Town of Leicester PLANNING BOARD

PLANNING BOARD AGENDA Tuesday September 7, 2021 @ 7:00PM

TO: Planning Board Members
FROM: Michelle R. Buck, AICP
Town Planner/Director of Inspectional Services
DATE: September 2, 2021
RE: **September 7, 2021 Planning Board Meeting**

Re: 1439 Main Street
Special Permit, Site Plan

SHEET NO.
C-2.0

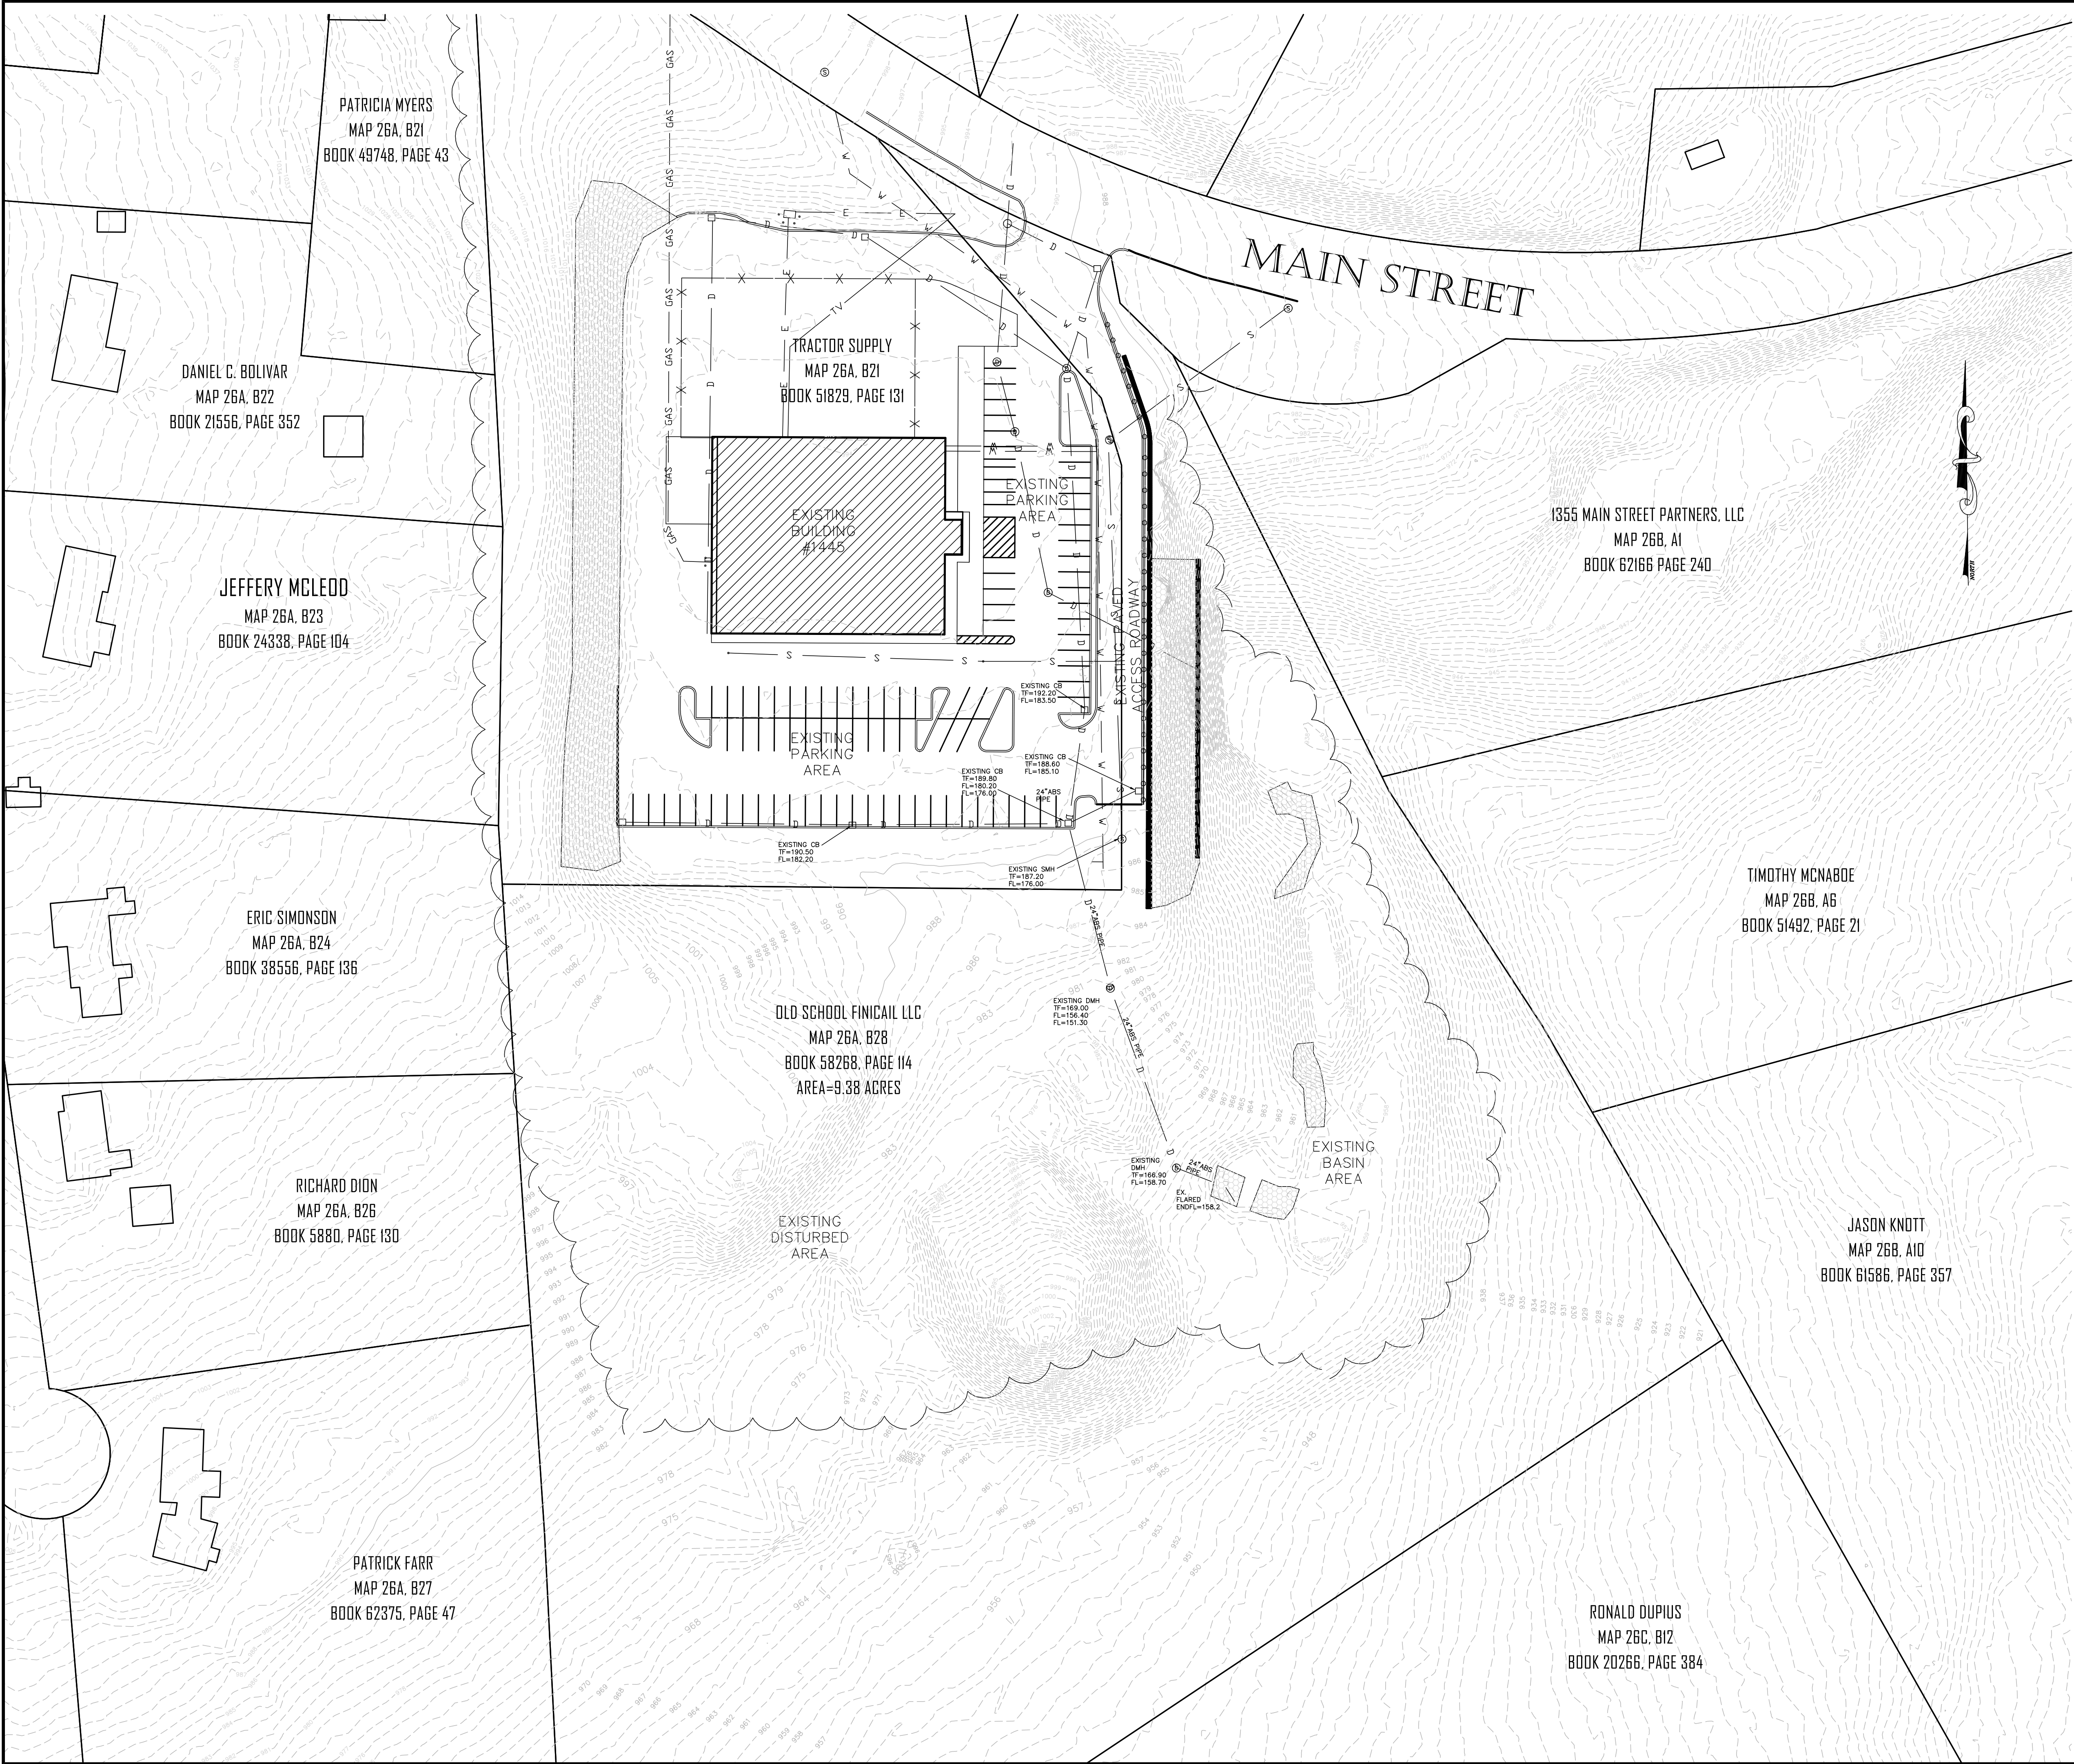
1. **Further Comment.** Submitted hydrologic analysis is based on only flows from the proposed area of filling, however, the existing stormwater basin collects flows that area as well as the existing Tractor Supply site. All contributing flows into the basin must be included in the analysis.
2. **No Further Comment.** Engineer has added rip-rap to improve stability.
3. **Comment Stands.** Engineer has stated that dust control will be implements, but the plans should define a means of dust control.
4. **Resolved.** Check dams on swales have been coordinated to function appropriately.

1. I have performed a Hydrologic Analysis on the proposed project to ensure that there will be no increase in runoff rates off site and therefore will not have a negative effect to abutting properties down gradient from this project. Please refer to Report.
2. The proposed 2:1 slope located along the downhill side of the project has been revised to have a rip rap slope constructed to provide soil stabilization during and after construction.
3. Dust control will be provided by propose watering of site during construction.
4. Rip rap swale along the top of the slopes have been added to collect runoff generated by the proposed project. Swale has been added along the southwest portion of the project to collect runoff before it leaves the site and directed toward the temporary basins.

ACCESS & STORM WATER BASIN BERM DRIVE CROSS-SECTION
N.T.S.

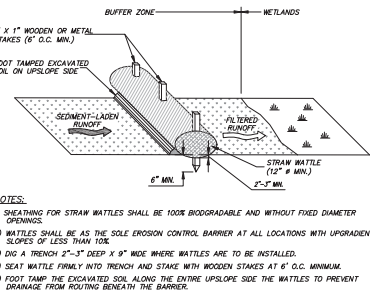
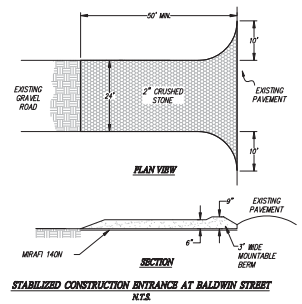
7. *The Stormwater Basin Cross Section, Sheet 8 of 8, calls for planting a row of thorny rose bushes ("Rosa Rugosa") along the outside crest of the stormwater basin berm (Infiltration Basin #2P), as a deterrent to entry. The roses cannot be planted on either the gravel access road, nor the Emergency Spillway. Some other means of restricting access over those areas must be developed.*
